Proposed Storefront Sections

Fasika Ethiopian Restaurant

SKD-2

## **Existing Facade**

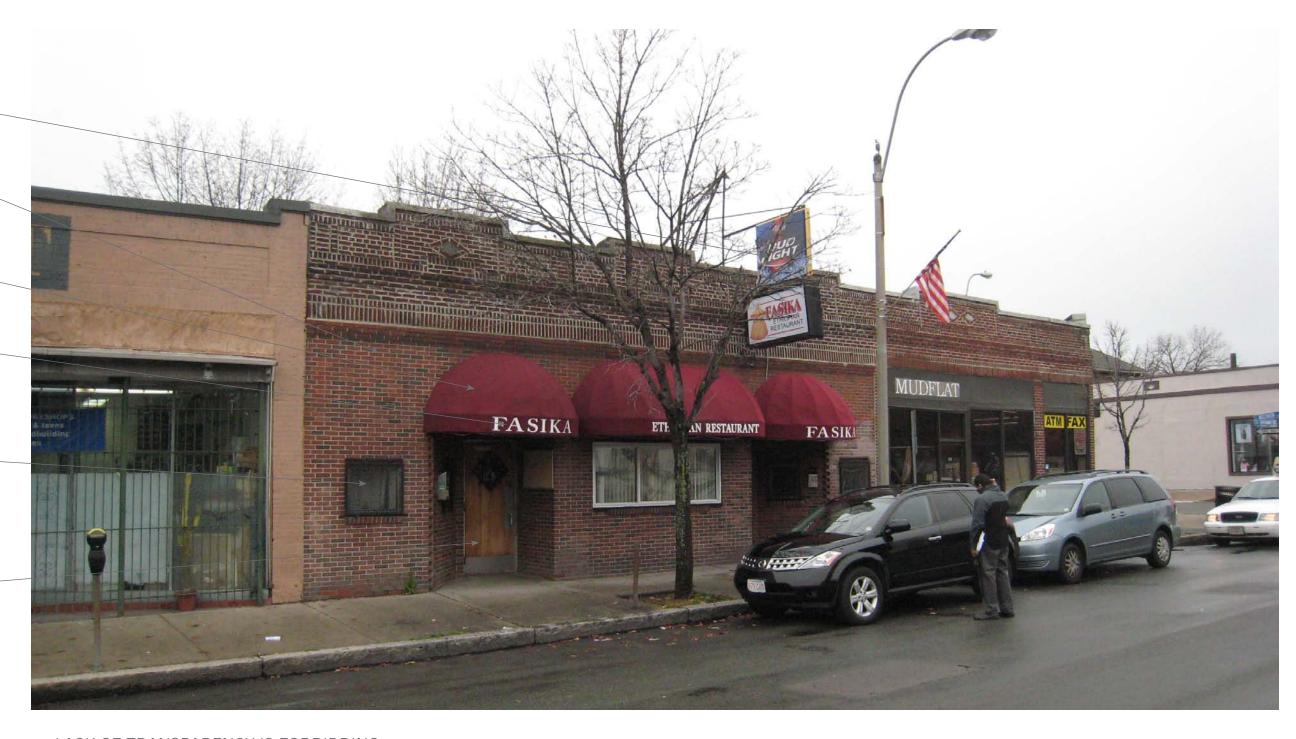
BLADE SIGN IS CLUNKY. UNCLEAR WHICH IS PRIMARY, FASIKA OR BEER?

BRICK INFILL DOES NOT MATCH FRIEZE **BRICK**

AWNINGS LOOK DATED; FORM IS OUT OF CONTEXT

> RESTAURANT NAME IS VERY LOW COMPARED TO NEIGHBORING STORES

BARRED PEEPHOLE WINDOWS ARE UNINVITING, PARTICULARLY FOR AN UNUSUAL CUISINE.

POINT OF ENTRY IS CONFUSING. SECOND ENTRY IS UNNECESARY

- LACK OF TRANSPARENCY IS FORBIDDING
- LACK OF COLOR
- ALMOST NOTHING IS IDENTIFIABLE WITH ETHIOPIAN CUISINE

## Scheme 3b

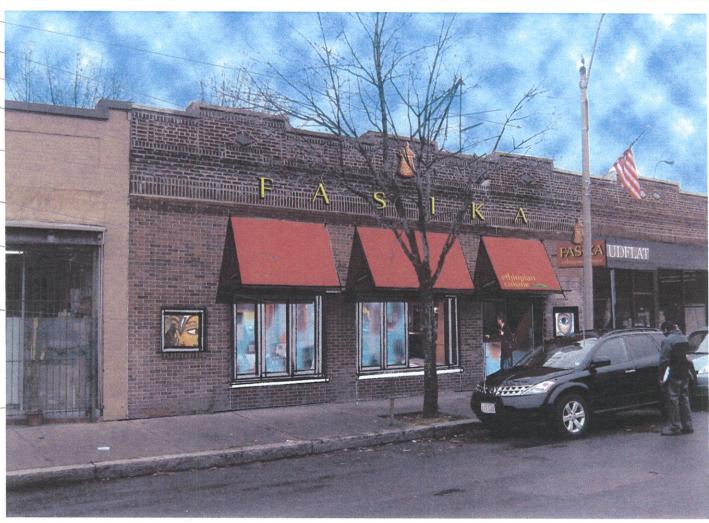
REMOVE EXISTING BLADE

> MODERN SIGN LIGHTS

1" ALUMINUM DIMENSIONAL ICON

1" ALUMINUM CHANNEL LETTERS PINNED TO FACADE

PAINTED METAL BLADE SIGN WITH RAISED LETTERS

SUNBRELLA AWNING ON ALUMINUM TUBE STRUCTURE

INFILL LEFT ENTRANCE WITH REUSED BRICK AND REPLACE EXISTING WINDOW WITH OPERABLE GLAZING BAND

> REMOVE GRILLE AND REPLACE WINDOW; ADD CUSTOM VINYL GRAPHIC

REPLACE ENTRY DOOR AND BRICK WING WALLS BEYOND WITH ALUMINUM AND GLASS STOREFRONT SYSTEM (3-SIDES)
